SALISBURY REGIONAL PARK PHASE 1

SITE PLAN

SITE PLAN SUBMITTAL
Page 1 of 313

POND A FOREBAY

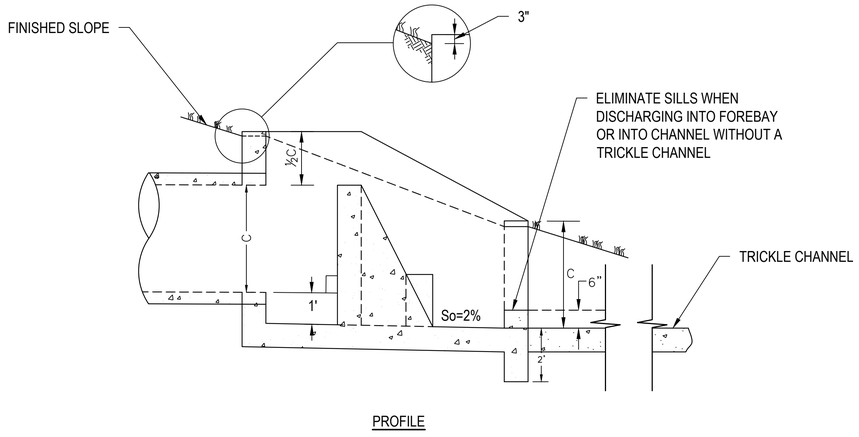
Please provide a detail for the pond trickle channel which complies with Figure 7.3 of the Town's SDECM.

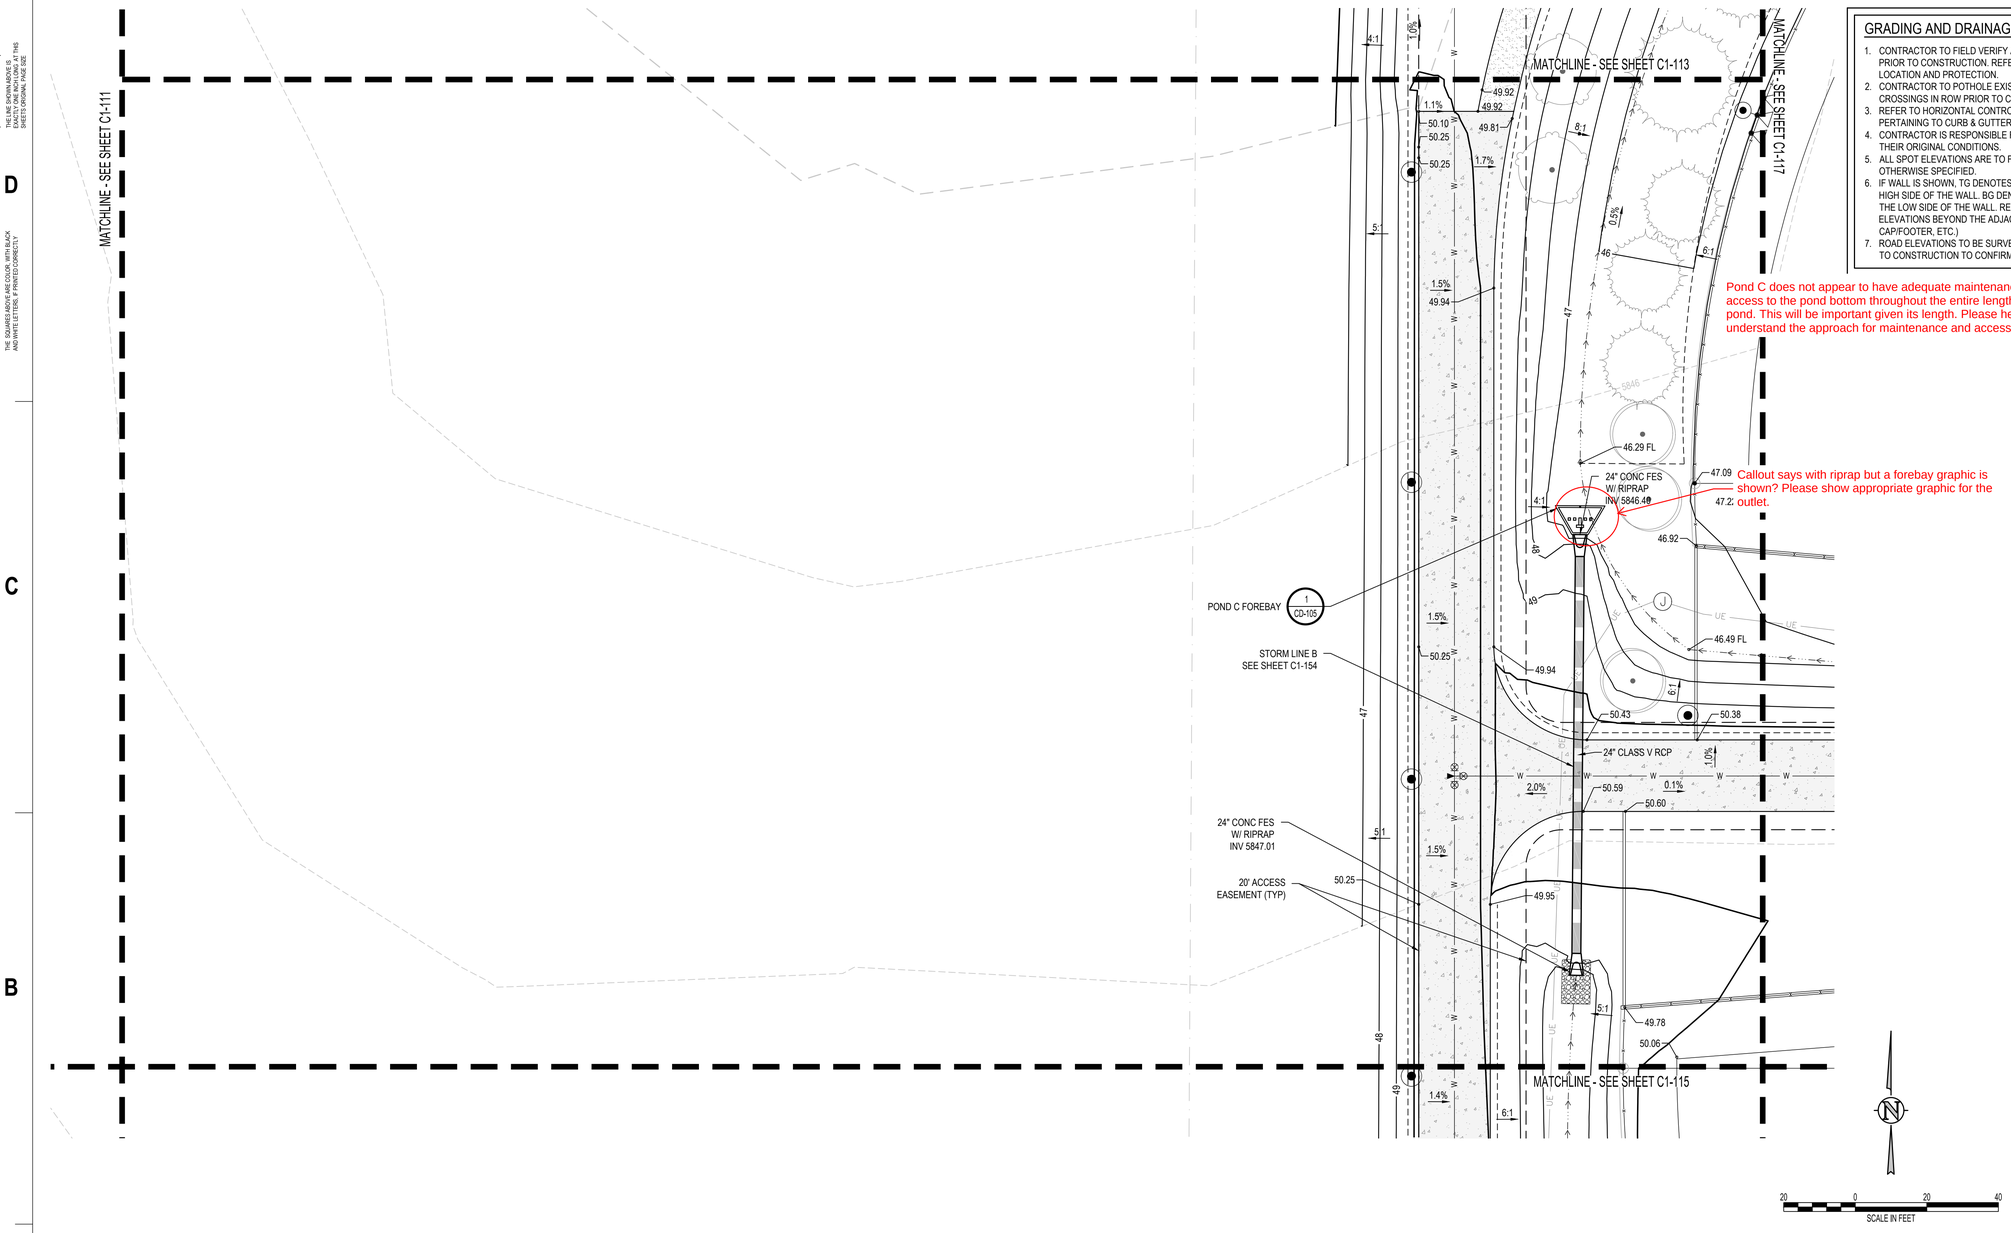
Pond C does not appear to have adequate maintenance vehicle access to the pond bottom throughout the entire length of the pond. This will be important given its length. Please help staff understand the approach for maintenance and access of Pond C.

Callout says with riprap but a forebay graphic is shown? Please show appropriate graphic for the outlet.

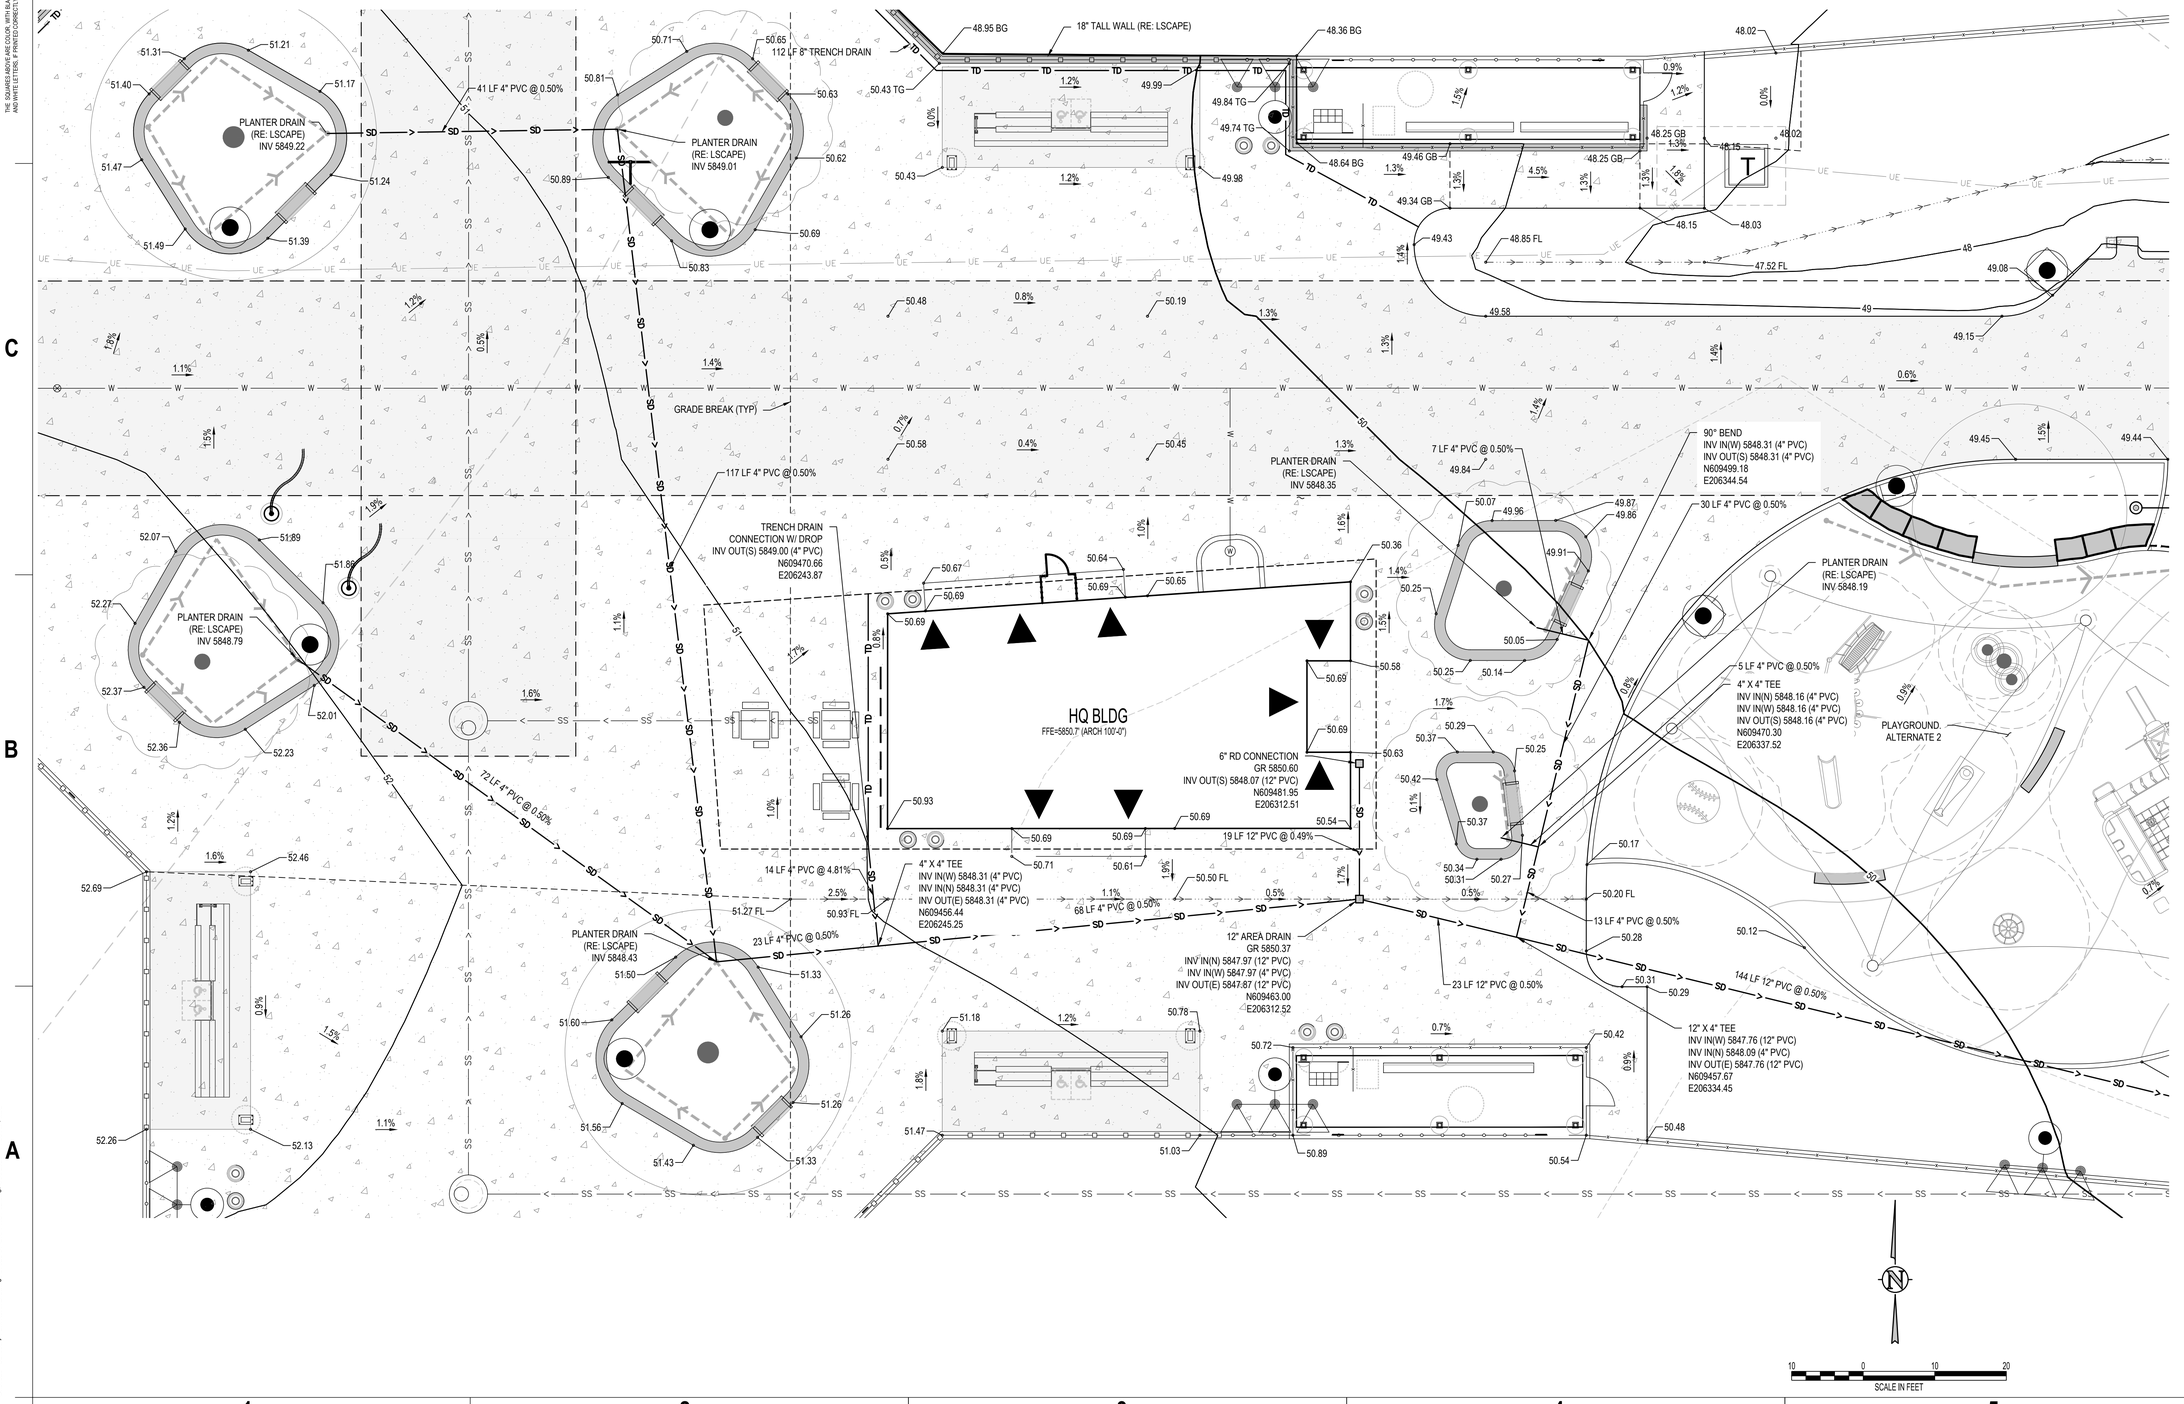
Provide a trickle channel for Pond A according to Town Standards and a detail for the pond trickle channel which complies with Figure 7.3 of the Town's SDECM. The detail should provide a minimum of all dimensions, elevations, material, reinforcement, and any other information necessary to construct the trickle channel in compliance with the drainage report.

STORM LINE C01 PLAN

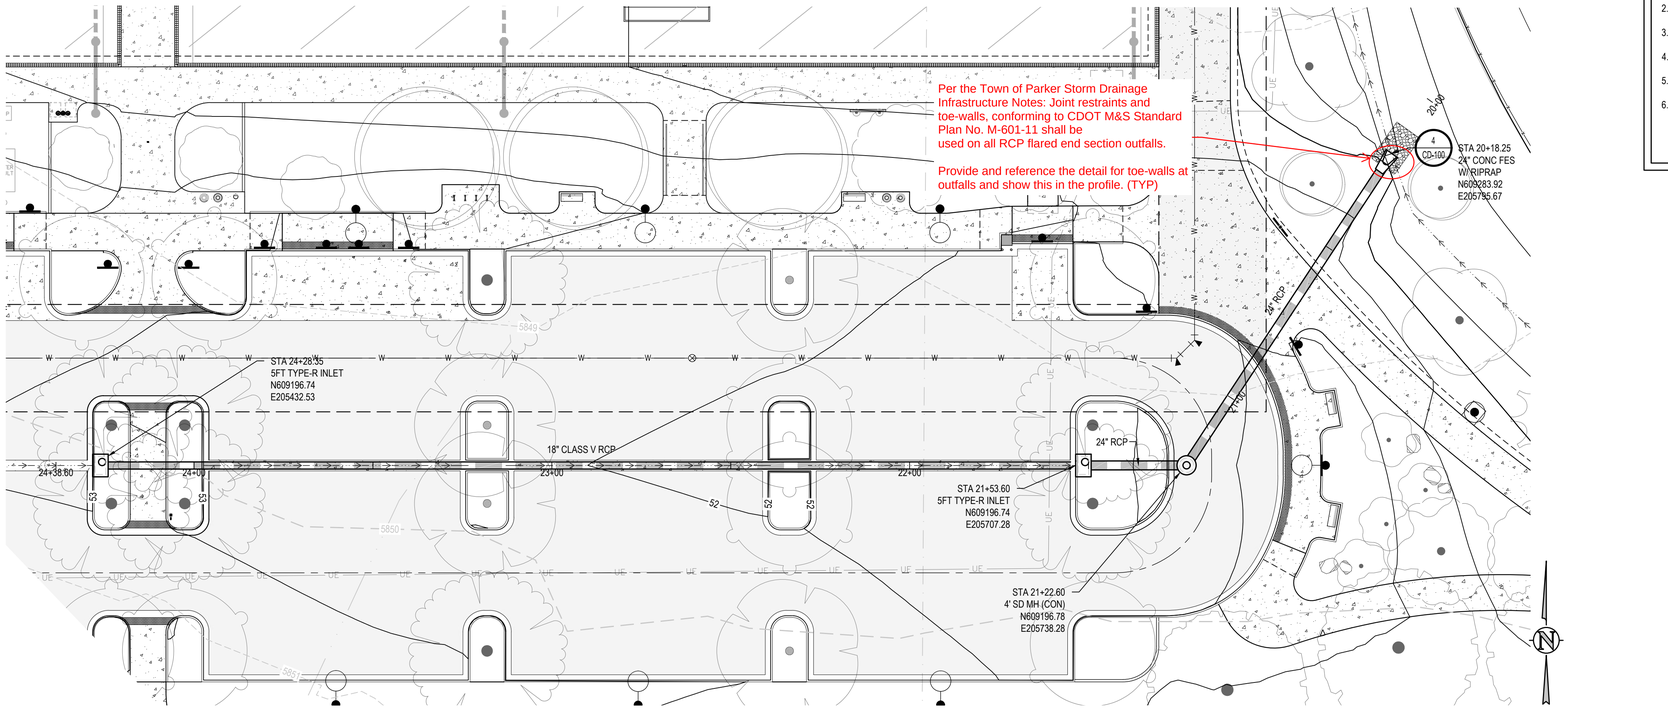
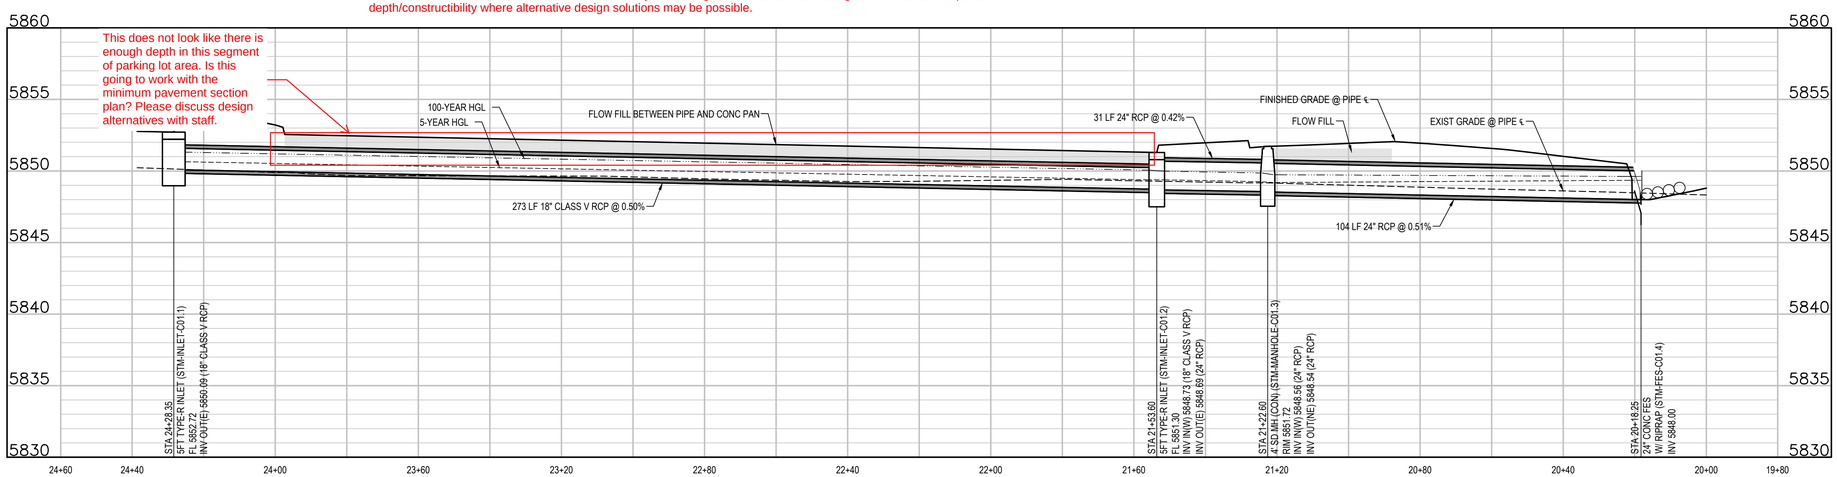
In General staff would like to discuss the constraints and reasoning related the variance requests for each problem area. There are some areas where the issue is more than just meeting criteria, but of and relating to the material and pavement depth/constructibility where alternative design solutions may be possible.

STORM LINE A04 PROFILE

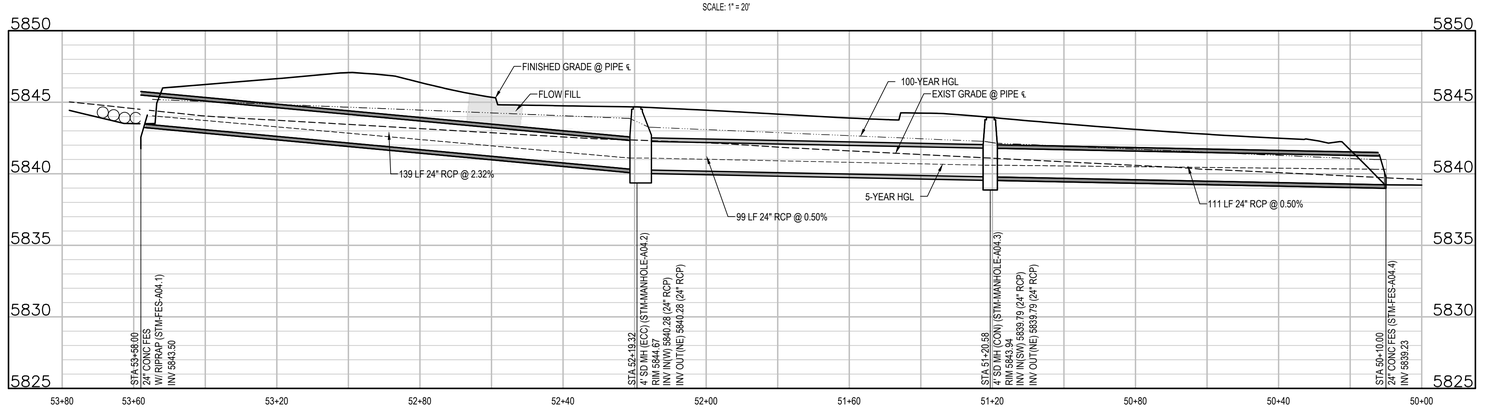
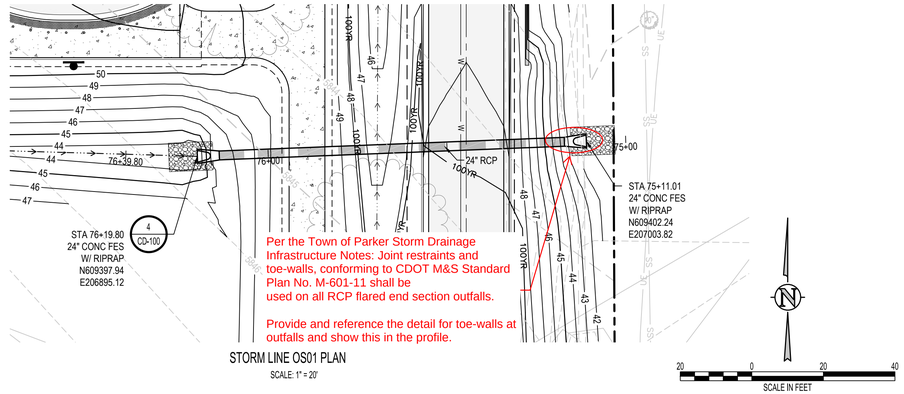
Provide and reference the detail for toe-walls at outfalls and show this in the profile.

Per the Town of Parker Storm Drainage Infrastructure Notes: Joint restraints and toe-walls, conforming to CDOT M&S Standard Plan No. M-601-11 shall be used on all RCP flared end section outfalls.
